SAFETY RECALL NOTICE

McLaren 600LT – Engine Radiator Upper Outboard
Coolant Hoses Replacement

Bulletin type:	Safety Recall Campaign
Reference number:	N/A
Campaign reference:	SRC 13 L 001
Attention:	Retailer Aftersales Managers, Retailer Sales Managers, Retailer Marketing Managers, Retailer Service Managers, Retailer Service Advisors, Retailer Technicians, Retailer Parts Managers, Retailer General Managers, All Retailer Staff
Affected vehicles:	McLaren 600LT Coupe, McLaren 600LT Spider
Situation:	Replacement of engine radiator upper outboard coolant hoses, RH and LH bank
Procedure:	Action all affected vehicles. Please refer to the information outlined in this document to complete the required work
Date:	21 September 2023

Image 1. Location of Upper Outboard Radiator Hoses, LH and RH bank

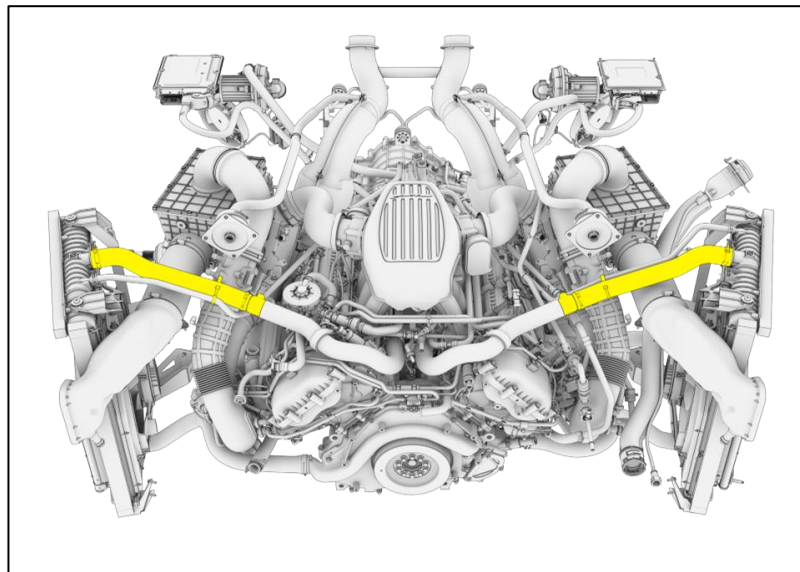
This voluntary safety recall relates to the risk of a potential coolant leak in the joint between the upper outboard radiator coolant hose and the temperature sensor housing - in particular during dynamic driving activities commonly associated with track running - due to inadequate sealing of the joint. The joint between the coolant hose and the temperature sensor housing is situated close to engine components which have a high operating temperature. If sufficient coolant is released in proximity to these components while at high operating temperature, it could result in thermal activity.

The below parts are required to action this rework and replace both engine radiator upper outboard hose assemblies RH bank and LH bank. All parts in the list below can be ordered in the usual way via Unidial 2.

The following components are not part of the recall; however, they are required to be replaced at the same time as part of the rework process. This is to ensure good fitment between the new plastic temperature sensor housing (contained with the outboard hoses) and the inboard coolant hoses – eliminating any effects that a deformation of the old hoses (as mated to a different housing) may have to the sealing of the joint.
